**Response to**  
**Request for Additional Information No. 467 (5333, 5344)**  
**Supplement 15**

**U.S. EPR Standard Design Certification**  
**AREVA NP Inc.**  
**Docket No. 52-020**

**SRP Section: 03.06.03 - Leak-Before-Break Evaluation Procedures**  
**SRP Section: 03.09.02 - Dynamic Testing and Analysis of Systems Structures and**  
**Components**  
**Application Section: FSAR Chapter 3**

**Question 03.06.03-28:****Follow-up to RAI 265, Question 03.06.03-26**

Figure 3.6.3-7—Pressure Only Leakage Rate versus Crack Length for Both Axial and Circumferential Crack Morphologies in Main Steam Line

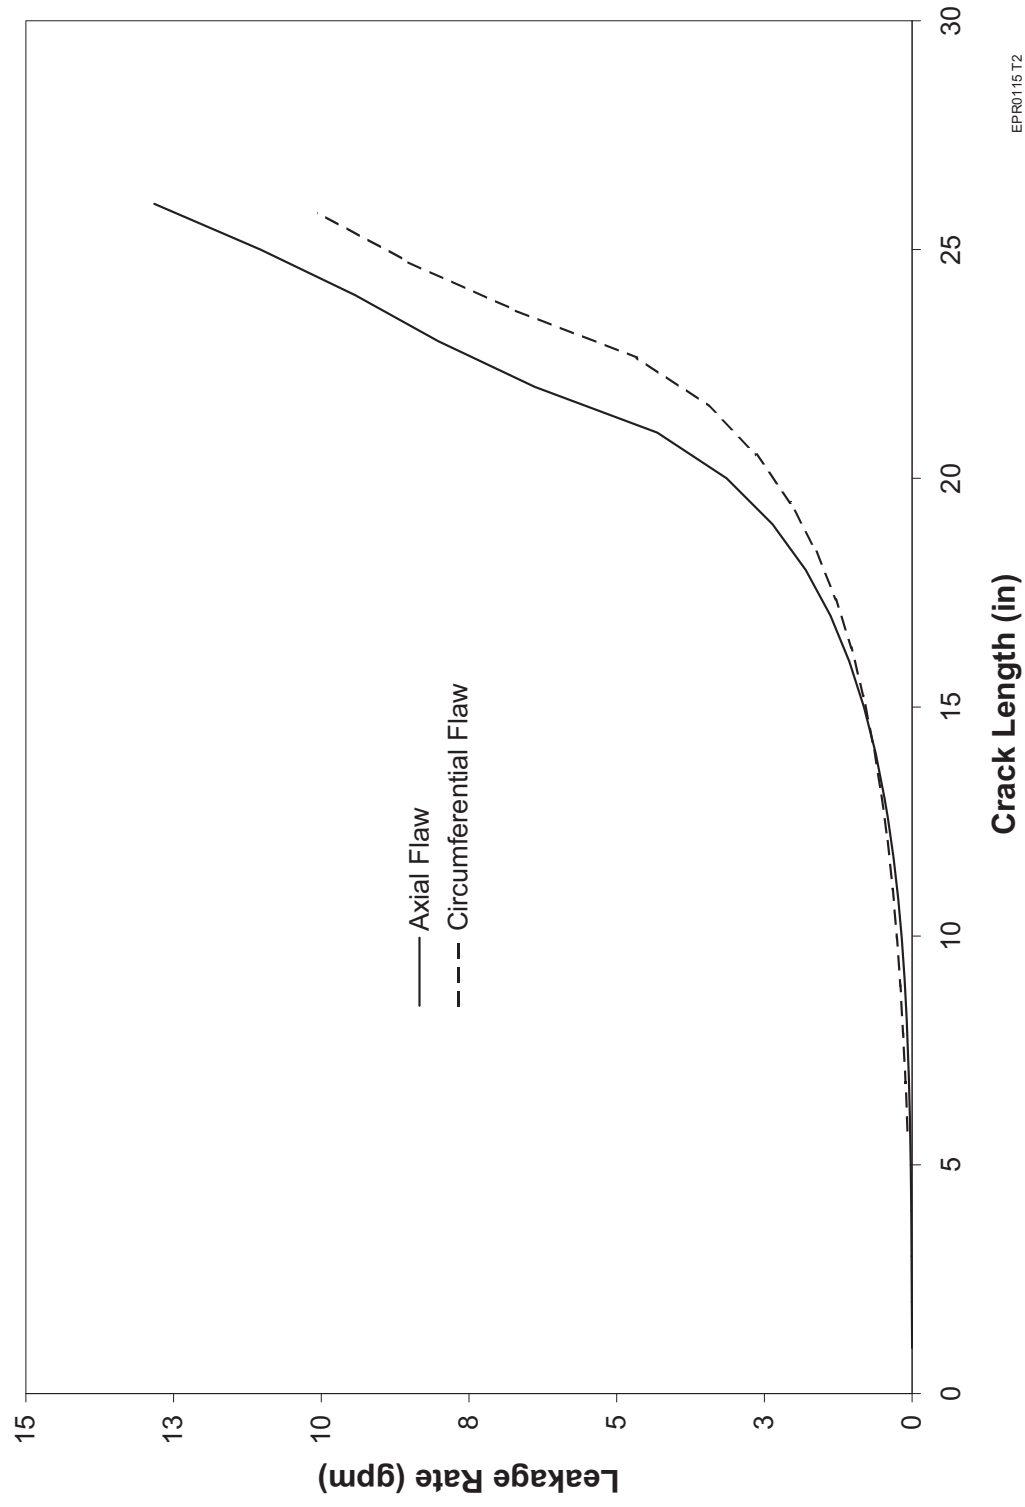
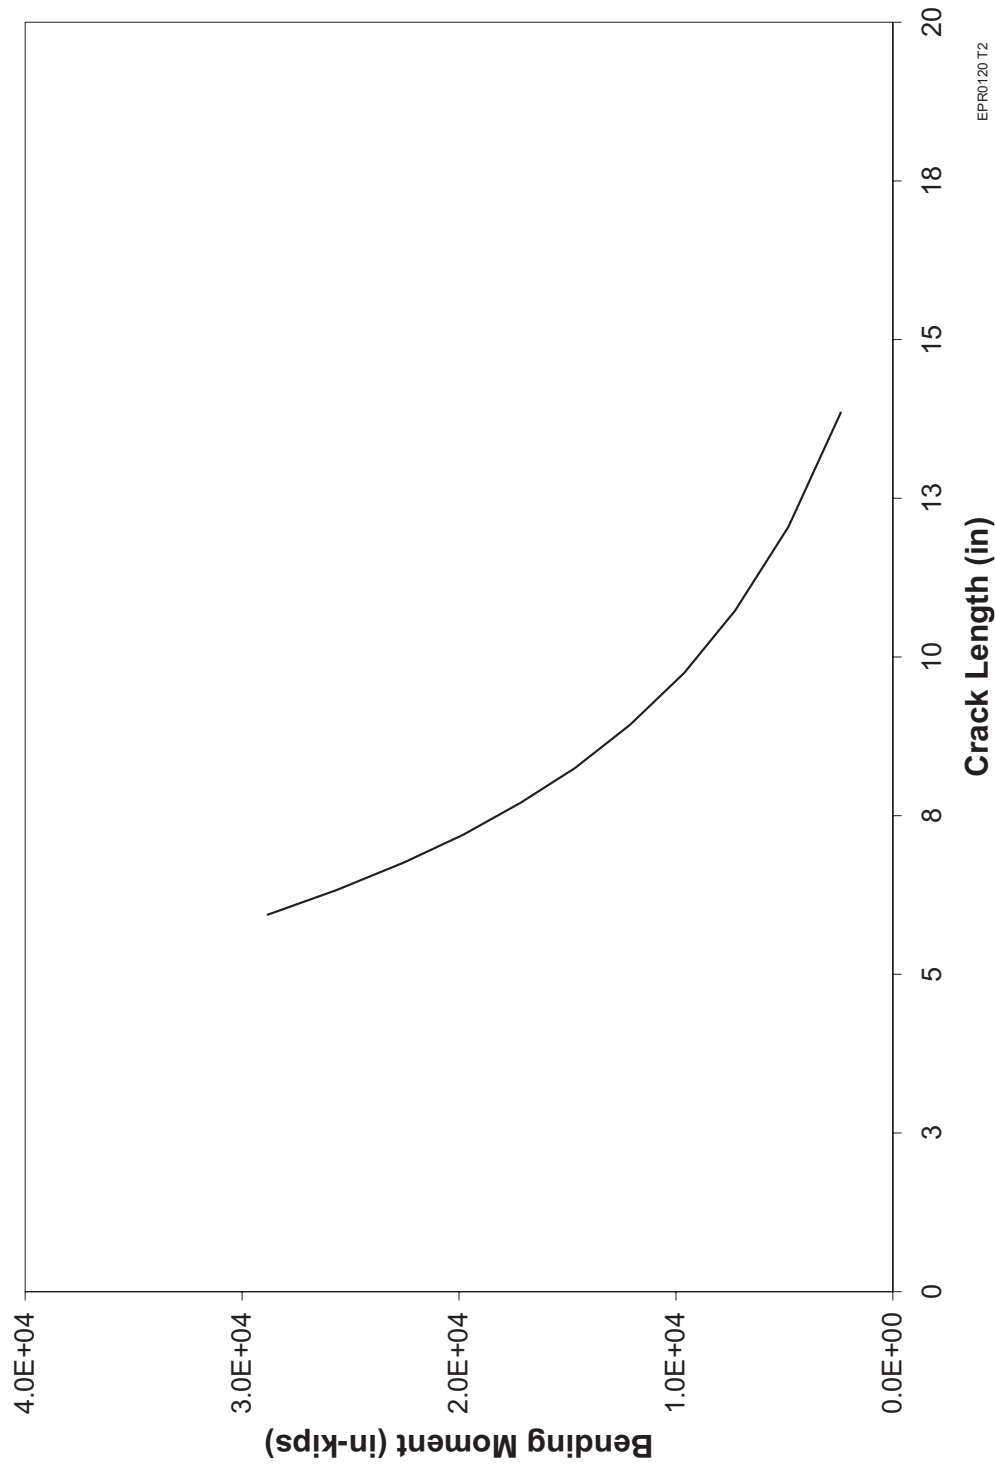
As noted in the question, the revised ALL diagrams for the SL were provided to the NRC in the Response to RAI 265, Supplement 5, Question 03.06.03-26. U.S. EPR FSAR Tier 2, Section 3.6.3 will be revised to include the revised ALL diagrams for the MCL. Corresponding changes will be made to the text and tables. The ALL diagrams for the MSL do not need to be revised for the following reasons:

- The leakage calculations for the MSL line were determined using SQUIRT with single phase steam, and the fatigue crack morphology was used demonstrating that the recommended number of turns was used. The NRC also performed independent confirmatory analysis and had similar leakage results to those performed by AREVA NP.

RAI 467  
03.06.03-28

Figure 3.6.3-12—ALL for Reactor Vessel Outlet Nozzle Region at Hot Leg (Location 1)

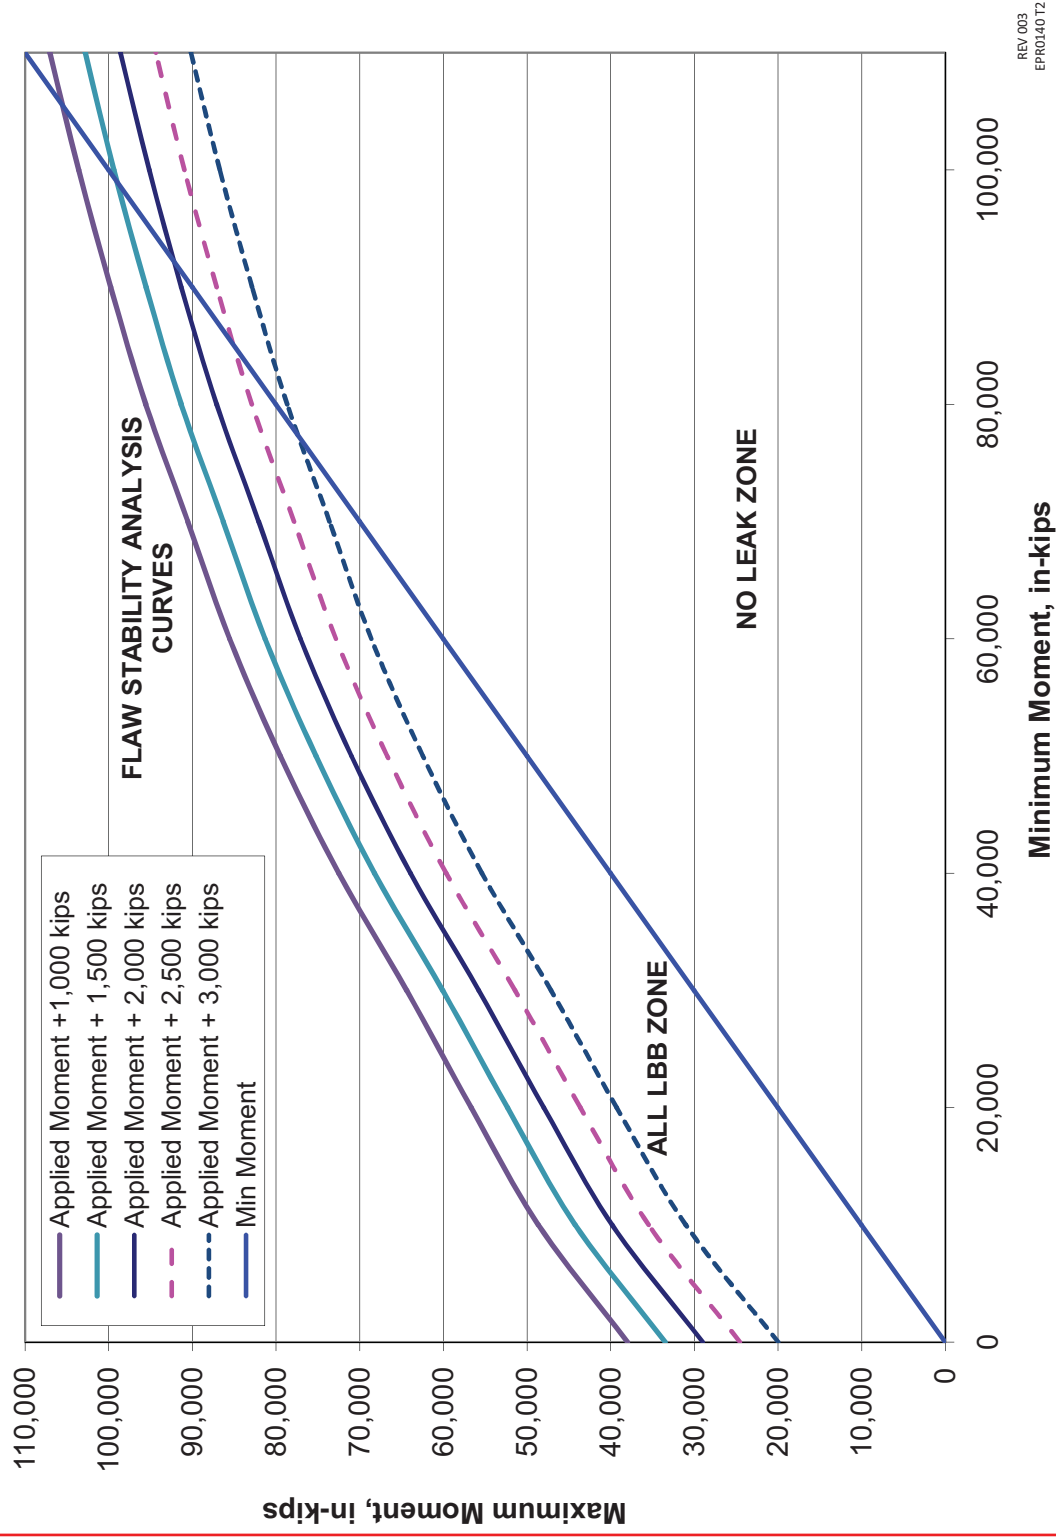
The Allowable Load Limit (ALL) Diagrams are presented in FSAR Tier 2, Section 3.6.3, Figure 3.6.3-12 through Figure 3.6.3-23 for the Main Steam Line (MSL), Main Coolant Line (MCL), and the Surge Line (SL) cases. As a result of the confirmatory calculations performed by the staff and the resulting RAI 265 Question 03.06.03-26, AREVA proposed (i.e., in its Supplemental 5 response to RAI 265 dated September 30, 2010) revising FSAR Tier 2, Figures 3.6.3-18, 3.6.3-19 and 3.6.3-20. Based on a telephone conference call with the applicant on April 7, 2010, the staff understood that AREVA would also revise the remaining ALL diagrams for MCL, MSL, and SL per the same procedure used for the SL. As stated in the telecon dated December 15, 2010, AREVA is requested to provide the NRC staff with revised versions of FSAR Tier 2, Figures 3.6.3-12,-13,-14,-15,-16,-17,-21,-22, and -23.

RAI 467  
03.06.03-28

Figure 3.6.3-24—ALL for RCP Outlet Nozzle (Location 7)

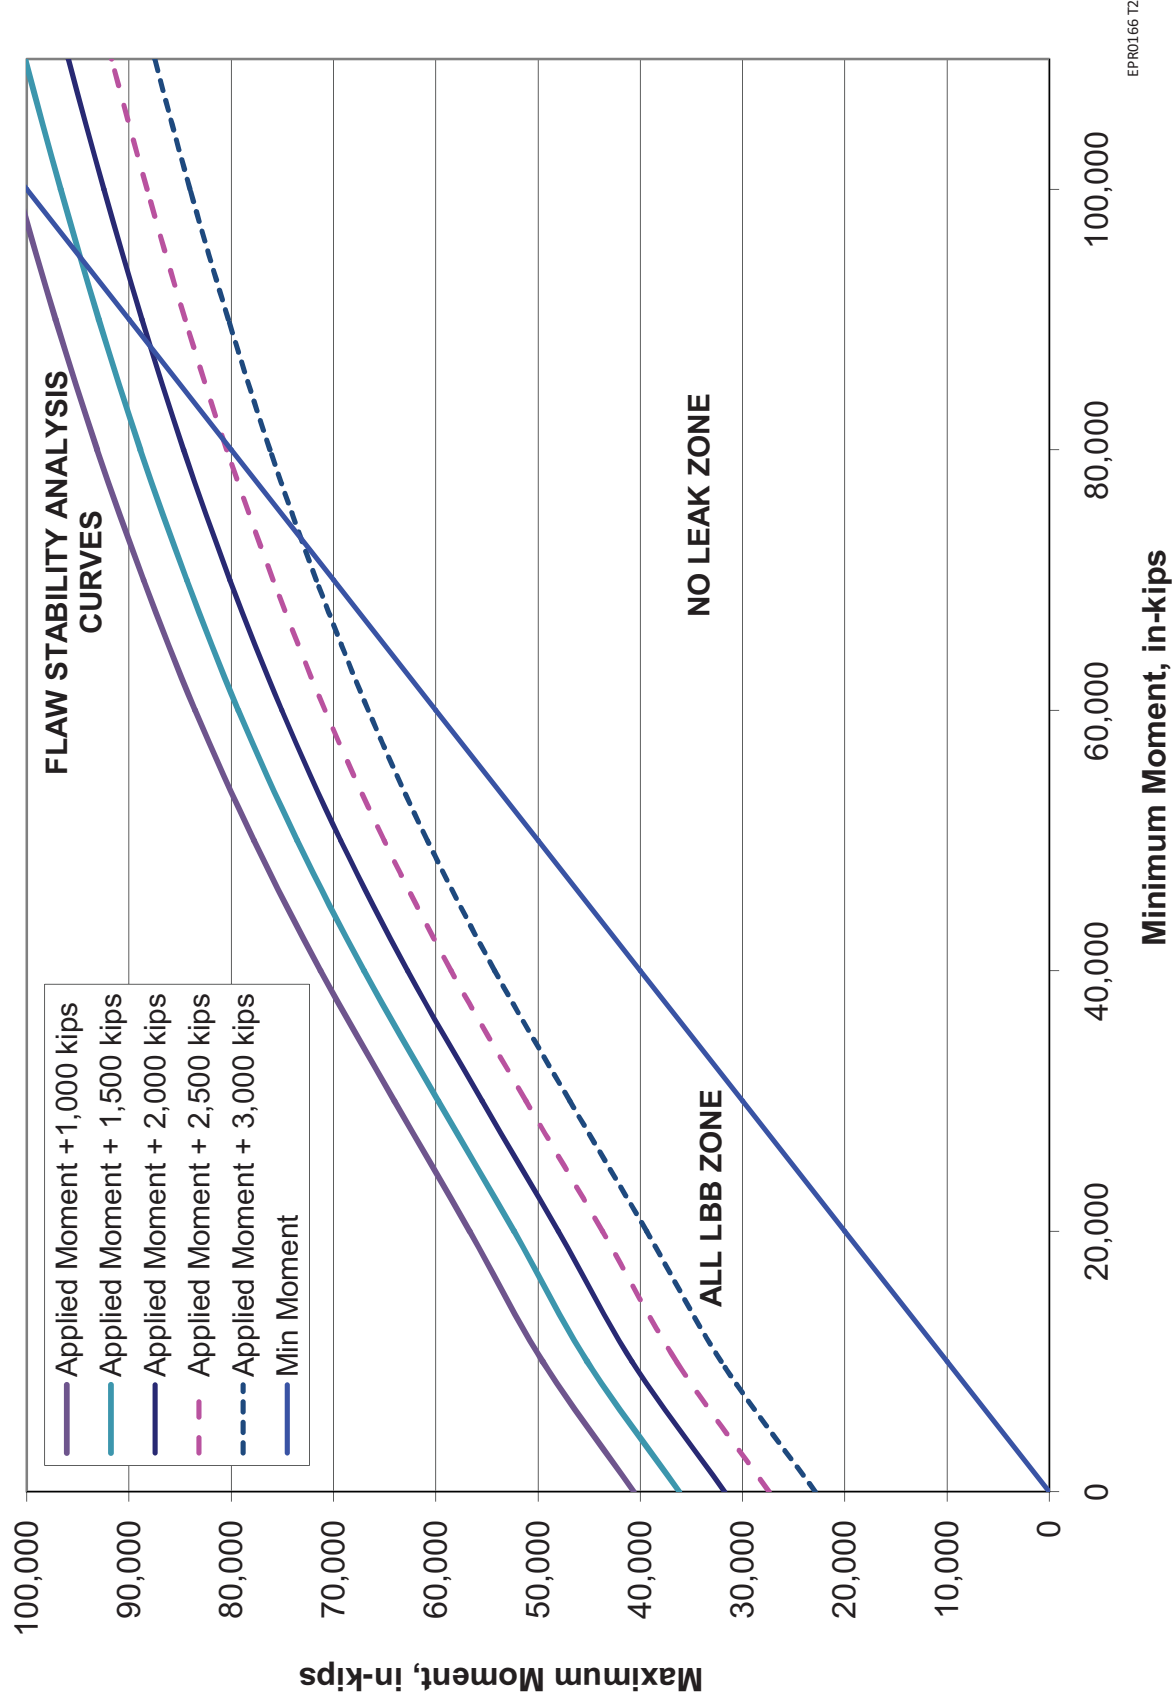
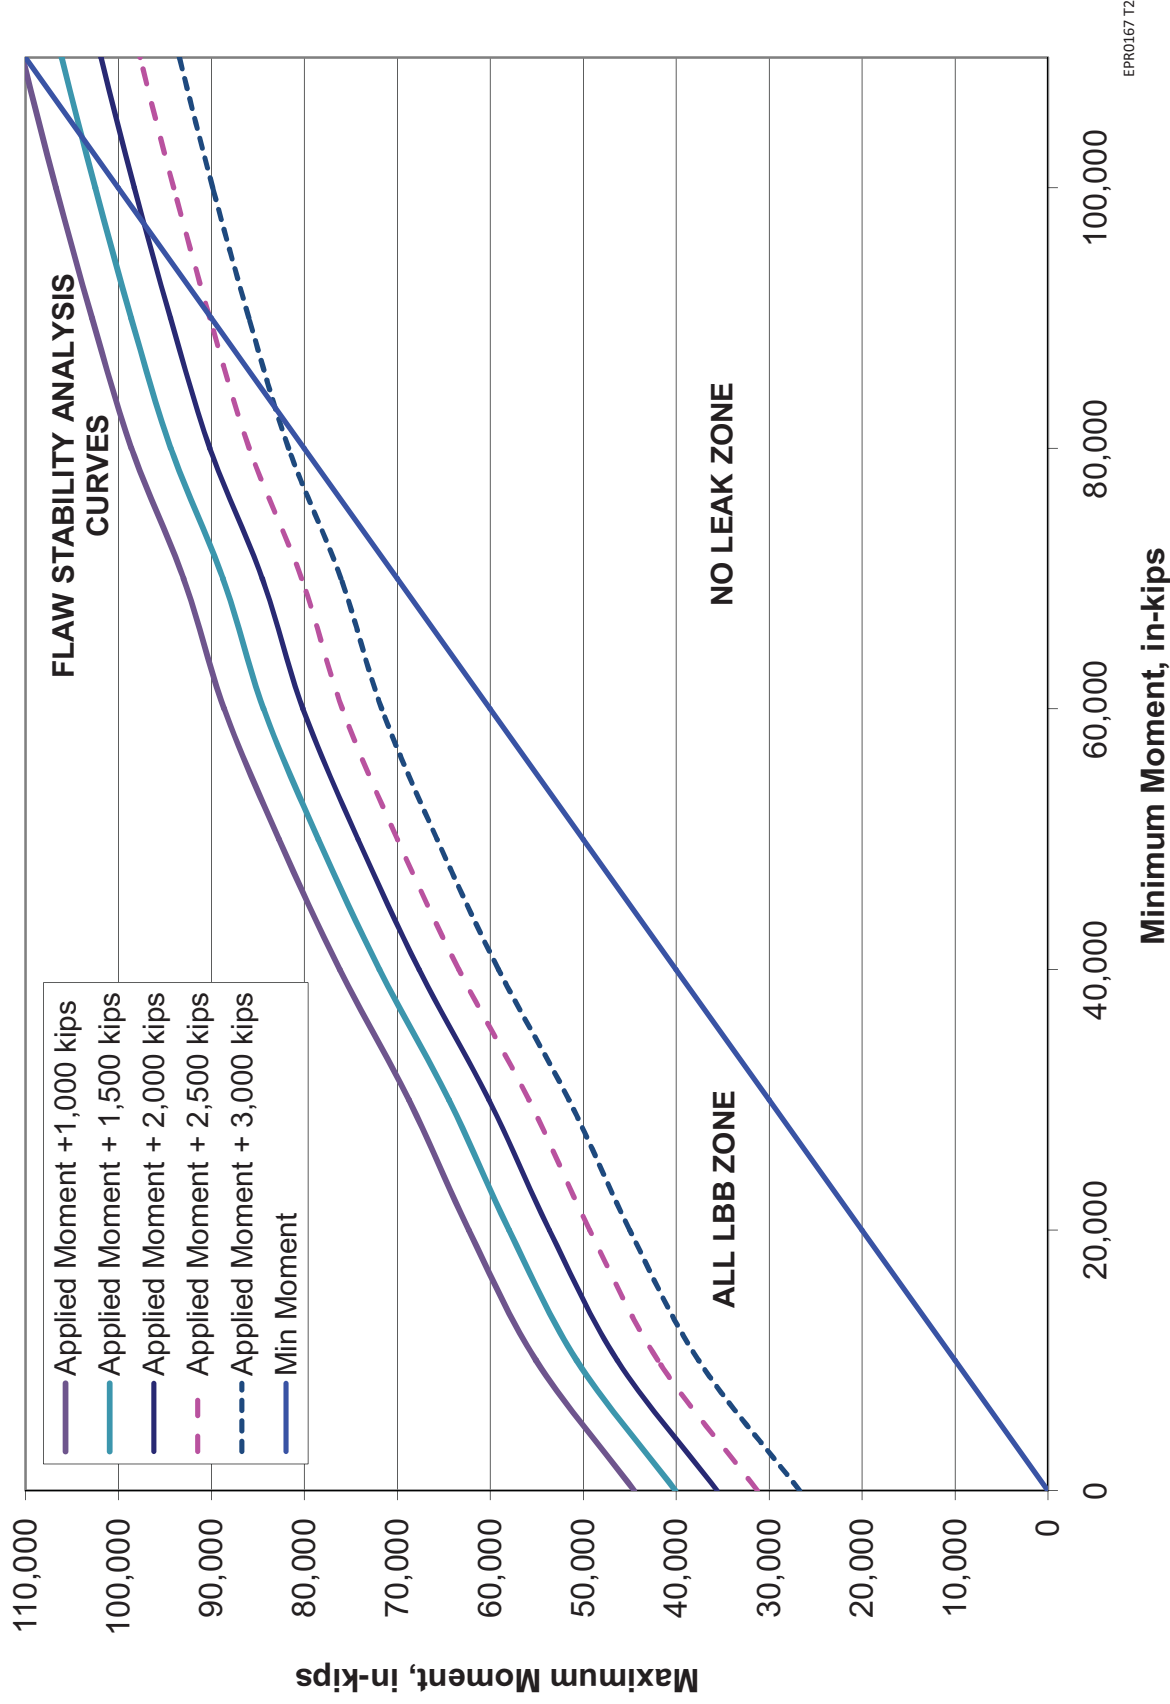
The explanations for the interpretation of the ALL diagrams are provided in Figure 3.6.3-12 through Figure 3.6.3-17, Figure 3.6.3-24 and Figure 3.6.3-25. As long as the maximum applicable moment (normal operating plus SSE loading) load for the applicable location is within the “ALL LBB Zone,” LBB is justified for that location. The maximum moment loads are derived considering various coincident axial loading conditions (1000 kilo lbs (kips), 1500 kilo lbs (kips), 2000 kilo lbs (kips), 2500 kips, and 3000 kips). The maximum axial loading (i.e., external applied loading plus 100 percent normal operating pressure end-cap load) that is applicable for the location is used as the maximum moment curve for the location. The “ALL LBB Zone” region is reduced as the axial loading is increased from 1000 kips to 3000 kips. The corresponding tabulated values for the ALL diagrams in Figure 3.6.3-12 through Figure 3.6.3-17, Figure 3.6.3-24 and Figure 3.6.3-25 are provided in the following tables:
